Notice of Modification

The project approval (MP 08_0182) granted by the Land and Environment Court for Ashton Coal Mine – SEOC Project on 17 April 2015.

Figure 8: SEOC project Biodiversity Offset Strategy

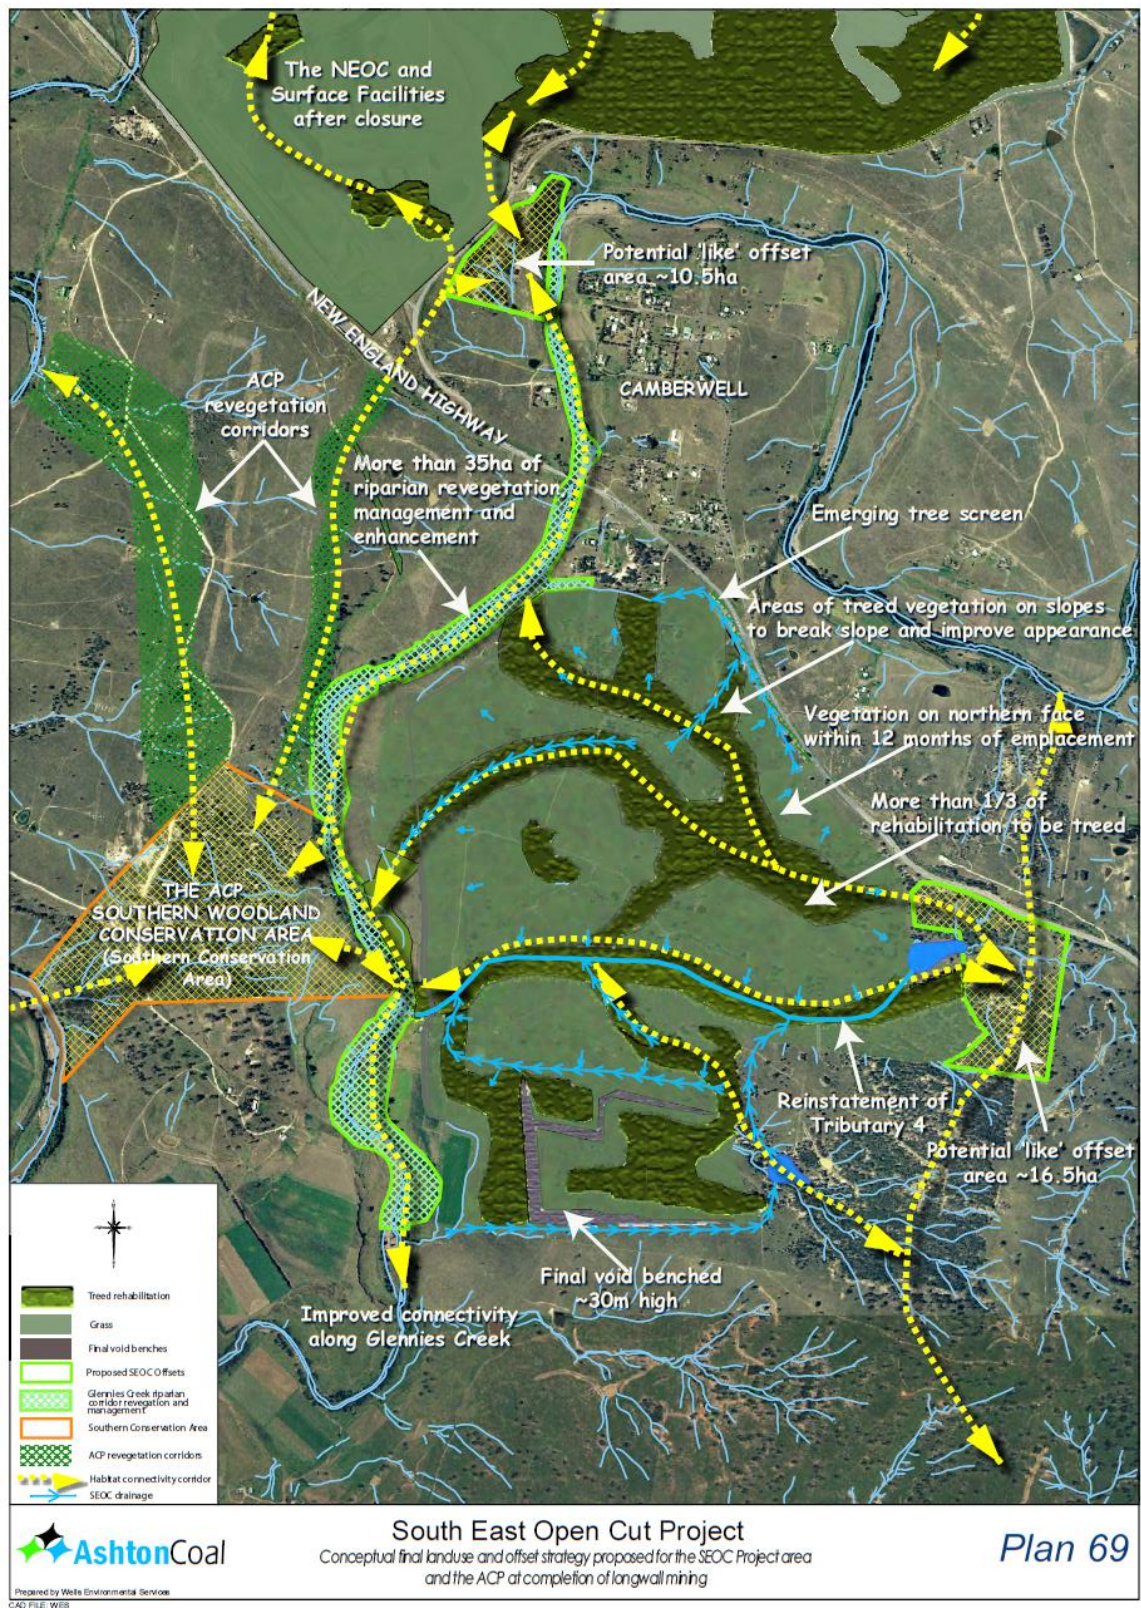
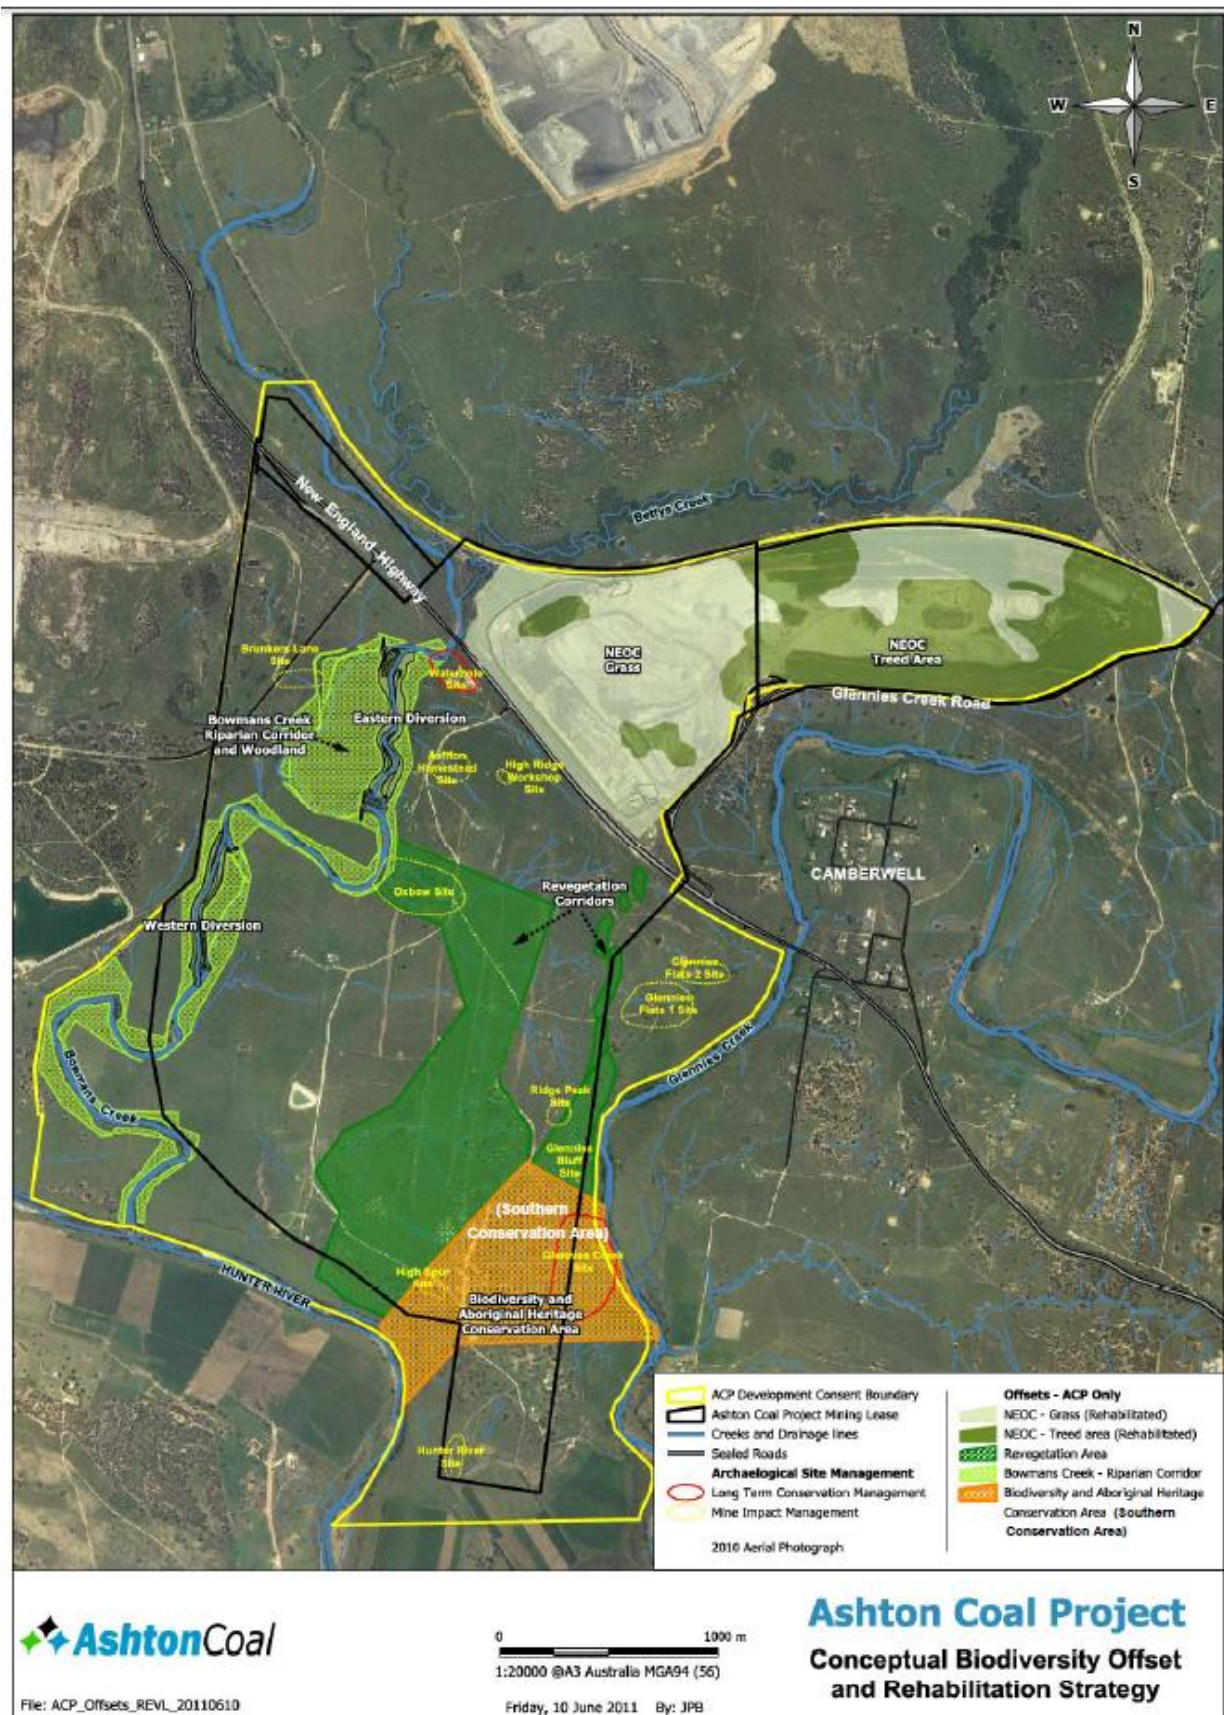
21. In Appendix 5:

- a. after the figure insert “**Figure 7:** *SEOC rehabilitation plan Year 18*”
- b. insert the following figure and caption”
